SUBJECT: COMANCHE PEAK NUCLEAR POWER PLANT, UNITS 3 AND 4
DOCKET NUMBERS 52-034 AND 52-035
RESPONSE TO HYDROLOGY SAFETY REVIEW OPEN ITEMS
(SECTIONS 2.4.12, 2.4.13, AND 2.5.4)

RAI 4314 (CP RAI #147) Question 02.04.12-8 S01
Question 02.04.12-9 S02

RAI 4315 (CP RAI #145) Question 02.04.13-5 S01
Question 02.04.13-6 S01
Question 02.04.13-7 S01

RAI 2929 (CP RAI #22) Question 02.05.04-11 S01

Figure 1-1 Revised Cross-Section Location Map

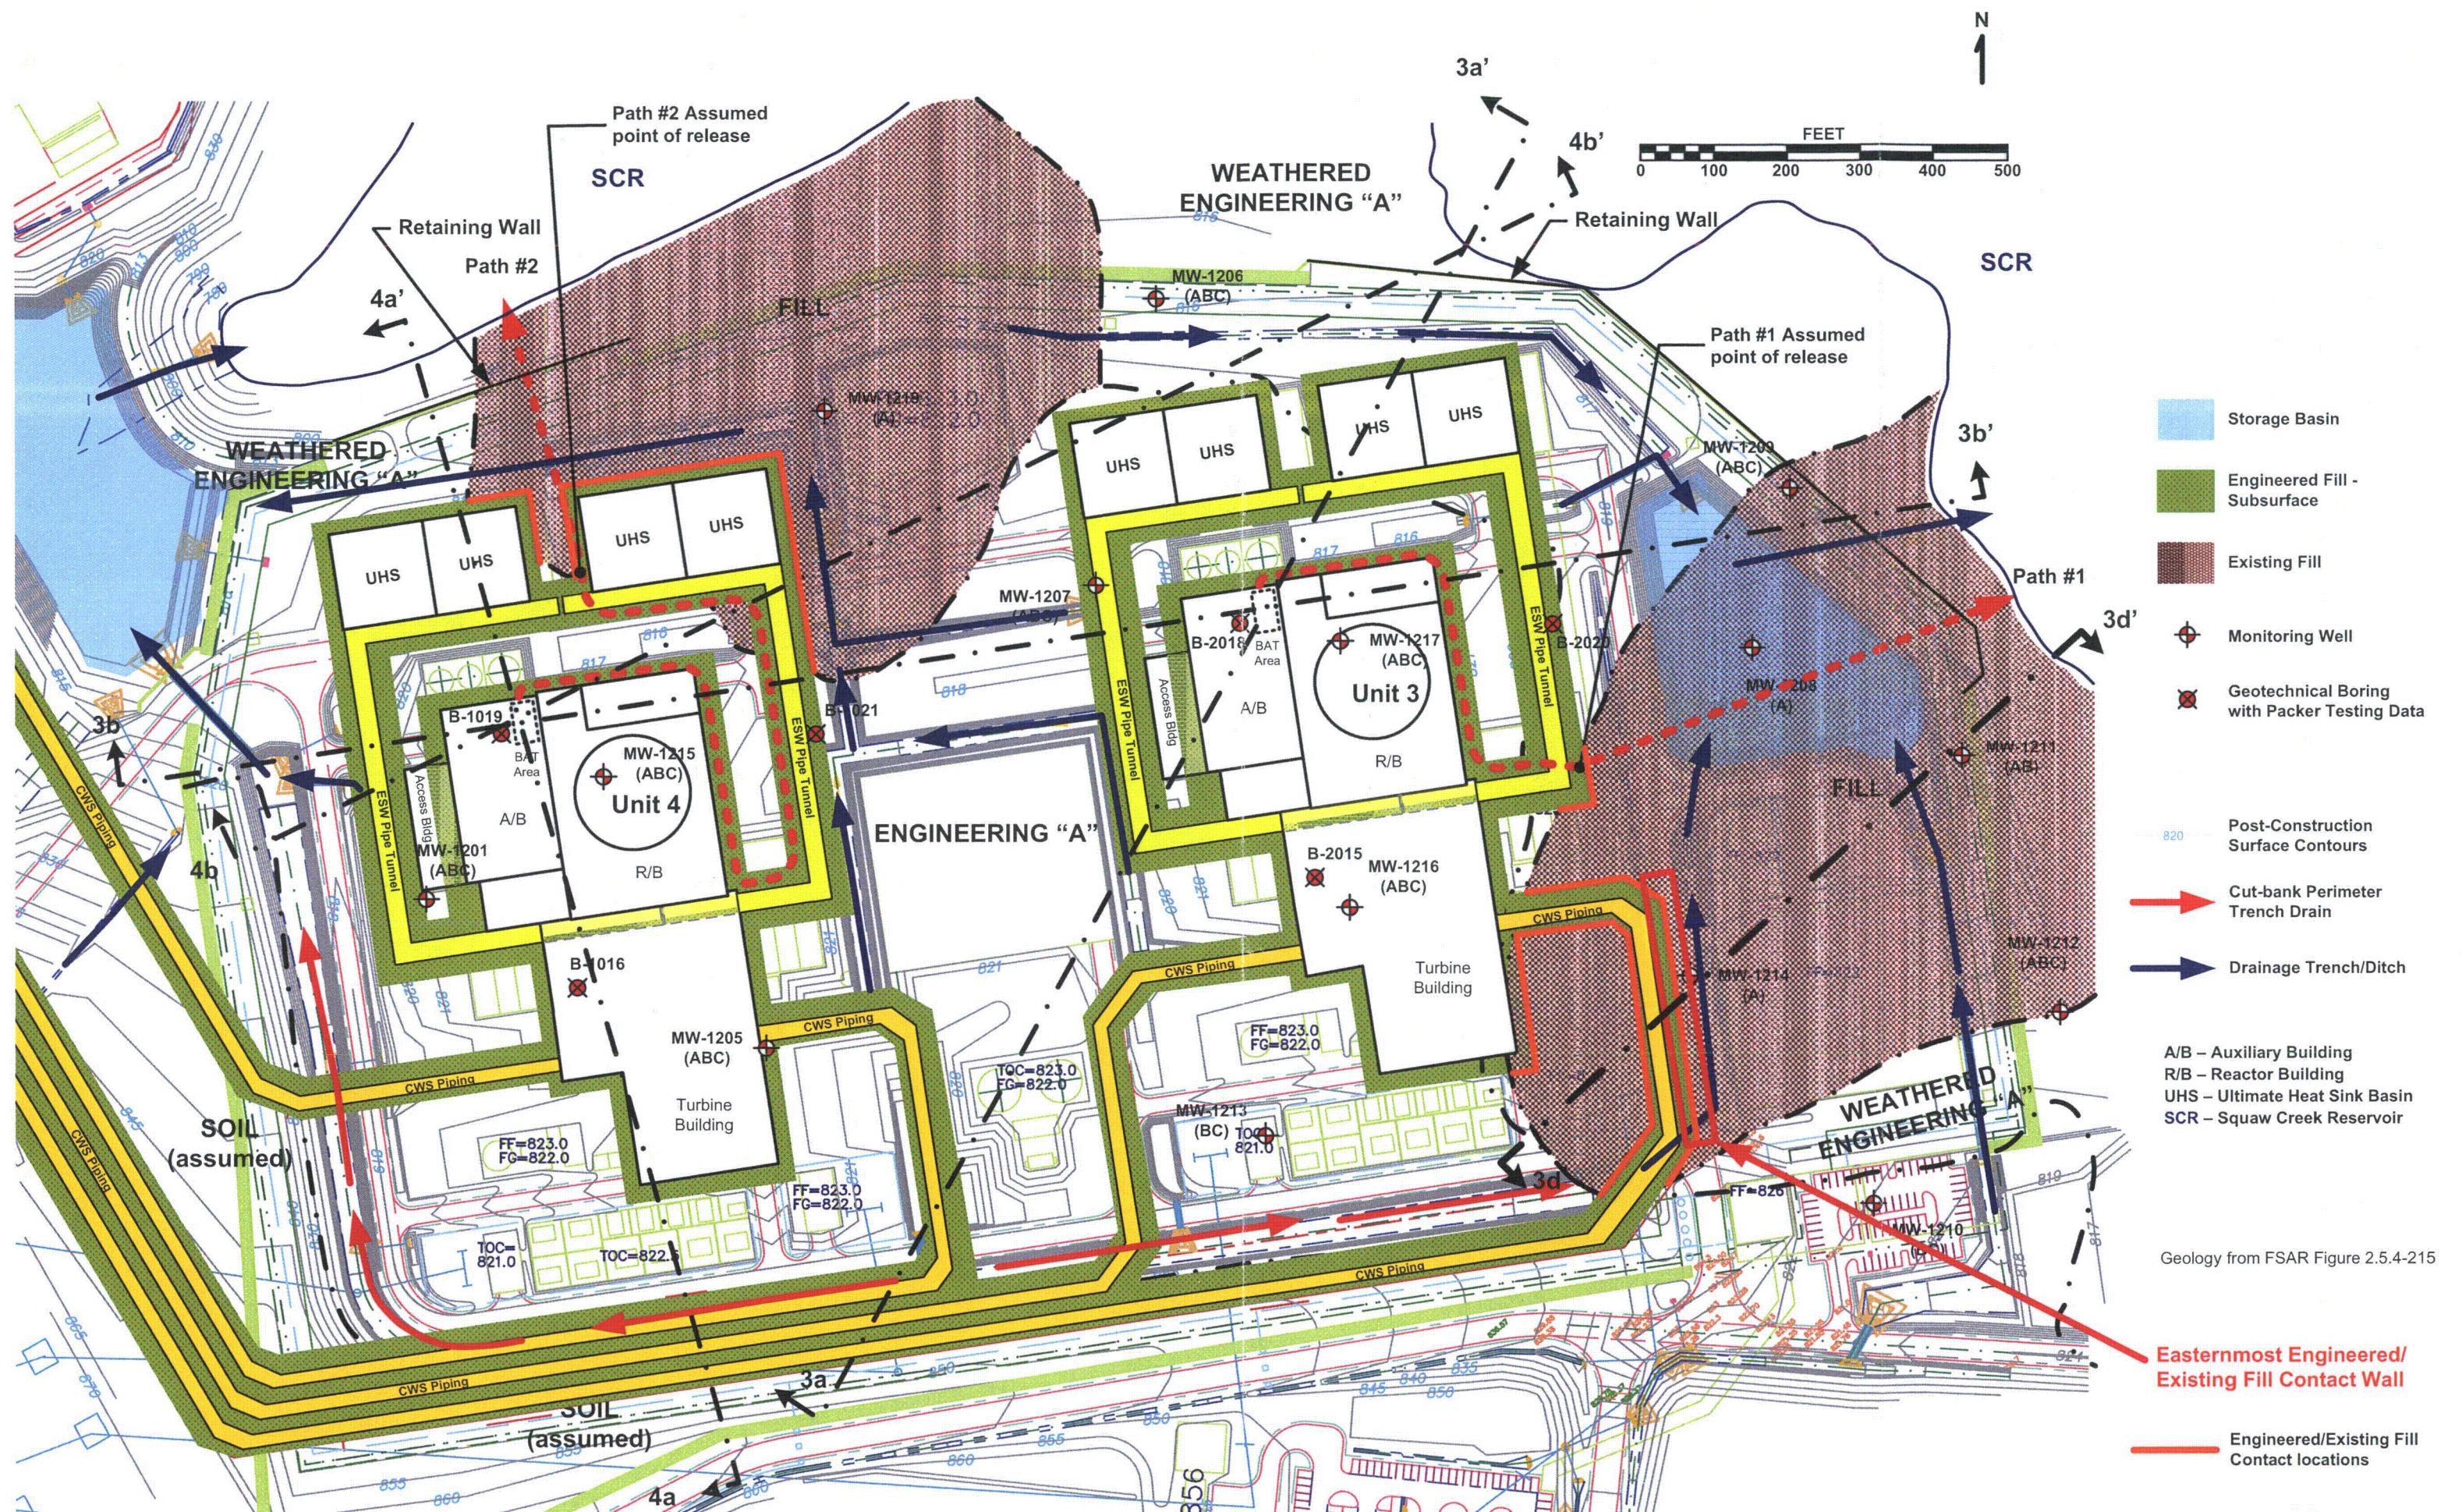
1) The applicant stated that there will not be any shallow groundwater at the site after construction is completed because the A and B zones will be removed and the surface water drainage system will be designed to prevent subsurface infiltration and preclude buildup near plant foundations. However, these statements are not sufficient to illustrate that the system will function as designed and to establish a

- 1) A qualitative description of the construction related impacts that could affect site hydrology including maps at a legible scale, sufficiently detailed engineering design information on drainage systems and a description of conservative measurements or estimates of hydrologic parameters. This information should be of sufficient detail to support an analysis of the impact of site modifications on site hydrologic processes such as infiltration, surface runoff, groundwater levels, hydraulic gradients and flow paths.
- 2) A conservative quantitative analysis that demonstrates that the estimated maximum operational groundwater level complies with the US-APWR Design Certification Document.

Following the original response and the NRC Hydrology Audit, the site grading and drainage plan was modified, resulting in changes to the maximum invert elevation of the southern and western cut bank trench drains, retaining wall modifications, and the overflow elevations for the eastern stormwater retention basin as follows:

The extent of engineered fill placement is depicted on Figure 1-1. This figure shows the engineered fill within the Circulating Water System (CWS) piping trench¹ along the southern boundary of the plant site will underlie much of the southern cut bank. The CWS piping trench is shown between the western cut bank and the higher topographic areas to the west of the plant site. A significant portion of the CWS piping trench east of the Unit 3 turbine building is depicted as being in contact with the existing fill to the east of Unit 3 (see attached Figure 1-1). Due to its down-gradient position, the existing fill will provide a drainage location for the engineered fill.

Based on Figure 1-1, the easternmost contact wall between the CWS piping trench engineered fill and the eastern existing fill will be at least 350 ft wide (Figure 1-1) and 23.5 ft deep (maximum groundwater elevation at 813.5 ft msl minus elevation of the top of the piping trench fill concrete at 790 ft msl). Well MW-1214a (B2028), located near this contact location, reported the top of rock elevation at 781 ft msl. Therefore, this entire contact wall will be within the eastern engineered fill (Figure 1-6). This results in a contact surface area between the existing and engineered fill at that location of at least 8225 ft². This would be considered a minimum contact surface as excavation and stabilization requirements for installation of the CWS piping would most likely require additional excavation and placement of engineered fill or leveling concrete.

Figure 2.4.12-213 Post Construction Release Flow Path #1

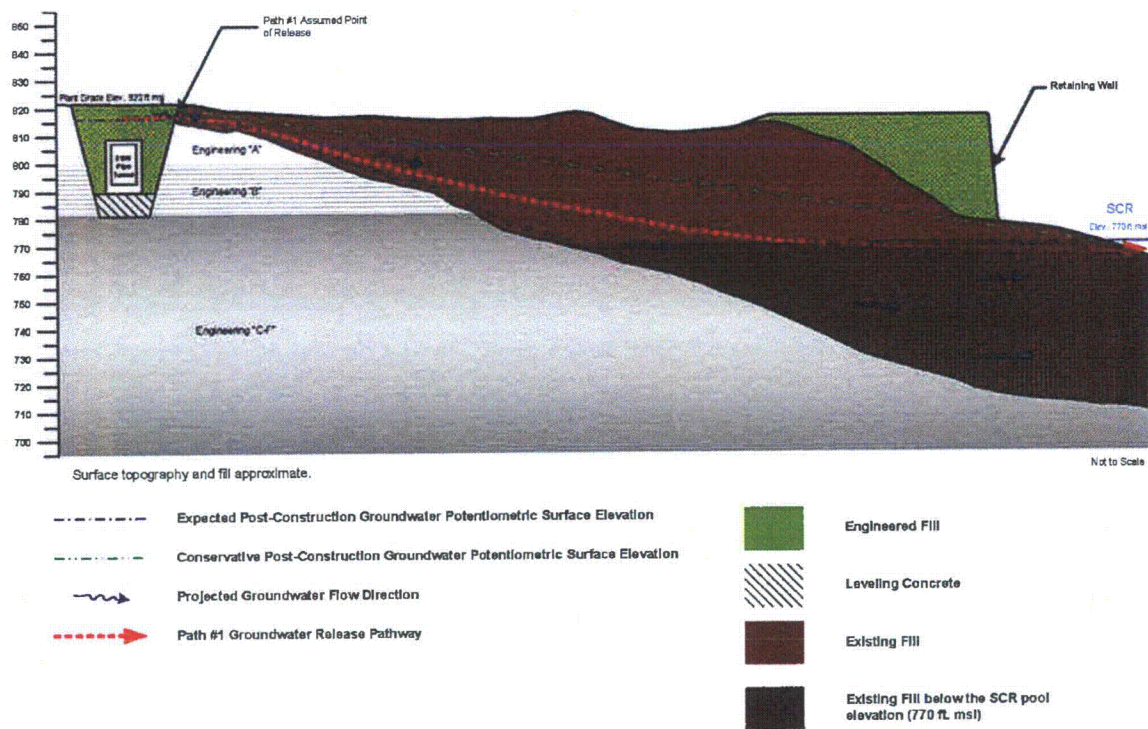
1. Provide adequate conceptual and site specific information on how the surface water and groundwater flow system is expected to change after Comanche Peak Nuclear Power Plant, Units 3 and 4 are constructed.
2. Provide an adequate site conceptual model supported by data, analyses and construction design information to support the conclusions presented.

For groundwater Path #1 (Figure 2.4.12-213), it is assumed that a release from the Unit 3 BAT would instantaneously travel out of the Unit 3 A/B into the engineered fill surrounding the A/B and R/B. For conservatism, it is assumed that this release would travel as a slug without any dilution within the groundwater present in the engineered fill. It would then travel through the engineered fill of the Unit 3 R/B and A/B and the ESW piping trench to the closest engineered/existing fill interface, located to the east of the Unit 3 turbine building (Figure 2.4.12-212). Since the hydraulic properties for the engineered fill have not yet been determined, it is assumed that the transport time to the fill interface will be negligible and no retardation or dilution of the released Unit 3 BAT contents is credited. At the assumed point of release, the released Unit 3 BAT contents will enter the existing fill east of Unit 3. The geometry and properties of the existing fill/engineered fill contact are presently unknown, therefore, for conservatism, it is assumed the contact will not retard any groundwater or radionuclide flow from the engineered fill into the existing fill. The released Unit 3 BAT contents will then travel 600 ft through the existing fill to the closest shoreline location on SCR. The travel time from the release point to SCR via the existing fill east of Unit 3 is conservatively estimated at 145 days.

As shown on Figure 2.4.12-213, the source term travel through the existing fill initially is at a higher elevation than the existing fill adjacent to the SCR embankment, thus producing the hydraulic gradient (Subsection 2.4.12.3). Once the source term reaches the groundwater in the existing fill that forms the embankment and infiltration point to SCR, the only motive force of infiltration to SCR is a change in SCR elevation.

Figure 2.4.12-215 Post Construction Release Flow Path #3

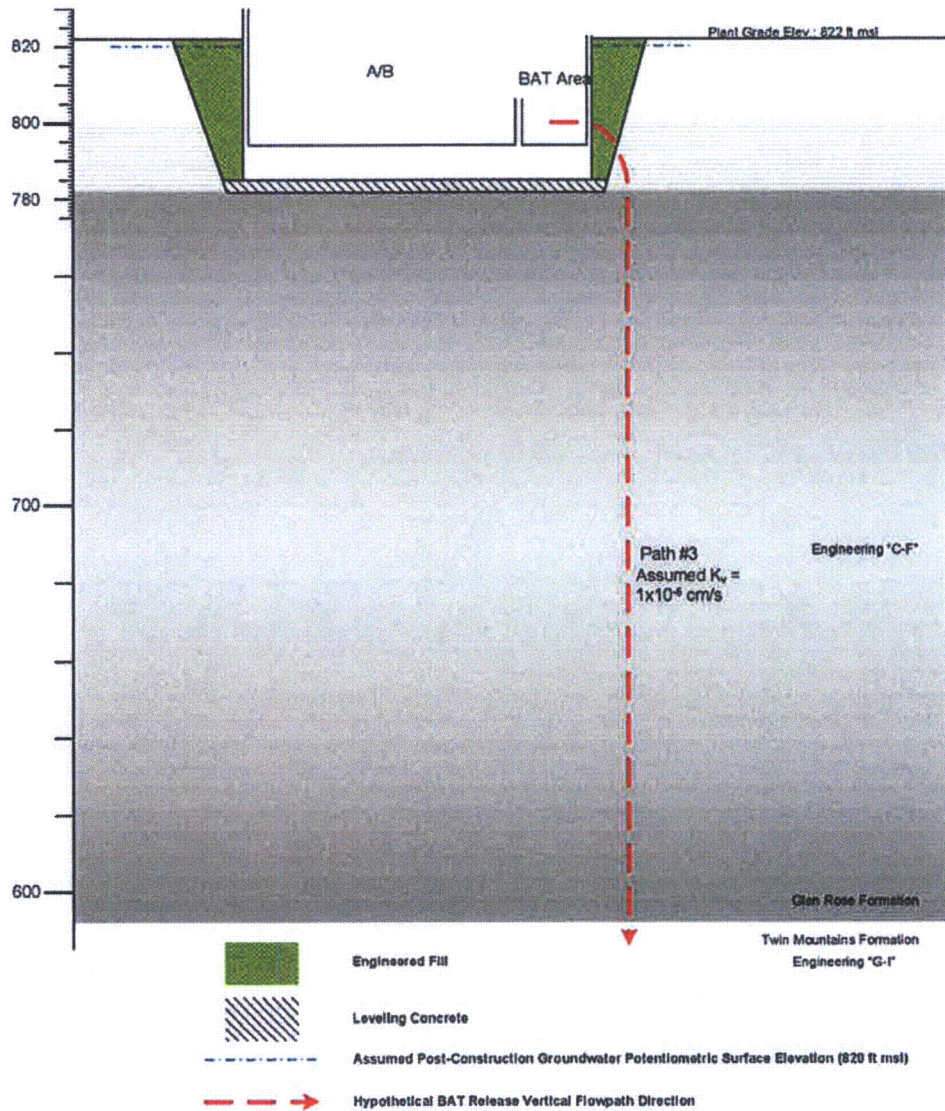
The NRC staff notes that offsite groundwater wells located within the Twin Mountains Formation could be potential receptors of groundwater flowing from the site. The applicant's response to this RAI seeks to eliminate the vertical pathway to the Twin Mountains Formation based on analyses performed as part of the Comanche Peak Nuclear Power Plant, Unit 1 and 2 evaluations and included in the Units 1 and 2 FSAR. However, these calculations showed that flow to wells within the Twin Mountains Formation was possible within approximately 400 years and that the resultant concentration of 137-Cs was above the 10 CFR Part 20 Appendix B Effluent Concentration Limits (ECL), despite the 400 year travel time. In addition, vertical migration calculations conducted for Units 1 and 2 do not appear to incorporate conservative, site specific conditions encountered at Units 3 and 4. Through review of information published by the U.S. Geological Survey (USGS) and the Texas Water Development Board (TWDB), the NRC staff has determined that since the construction of Units 1 and 2, water levels within the Twin Mountains Formation have fallen below the top of the Twin Mountains Formation in the area of the site, creating a downward gradient and the potential for a downward flow. As a result of these findings, the staff believes that site specific porosity measurements, distances between the bottom of the tanks and Twin Mountains Formation, vertical gradients and tank source terms are different for Units 3 and 4 than for Units 1 and 2.

For groundwater Path #3 (Figure 2.4.12-215), it is assumed that an instantaneous release from the BAT would travel out of the CPNPP Units 3 or 4 A/B into the engineered fill surrounding the A/B and R/B. Although vertical groundwater movement is considered improbable due to thickness and extremely low hydraulic conductivity of the lower Glen Rose limestone, a hypothetical pathway was evaluated using a higher hydraulic conductivity (1×10^{-6} cm/s) than those measured during site investigations. For conservatism, it was assumed this pathway would allow downward advective groundwater flow from the engineered fill material surrounding the A/B to the Twin Mountains Formation. The travel time from Units 3 or 4 to the Twin Mountains Formation via the postulated vertical pathway is conservatively estimated at 6858 days (18.78 years).
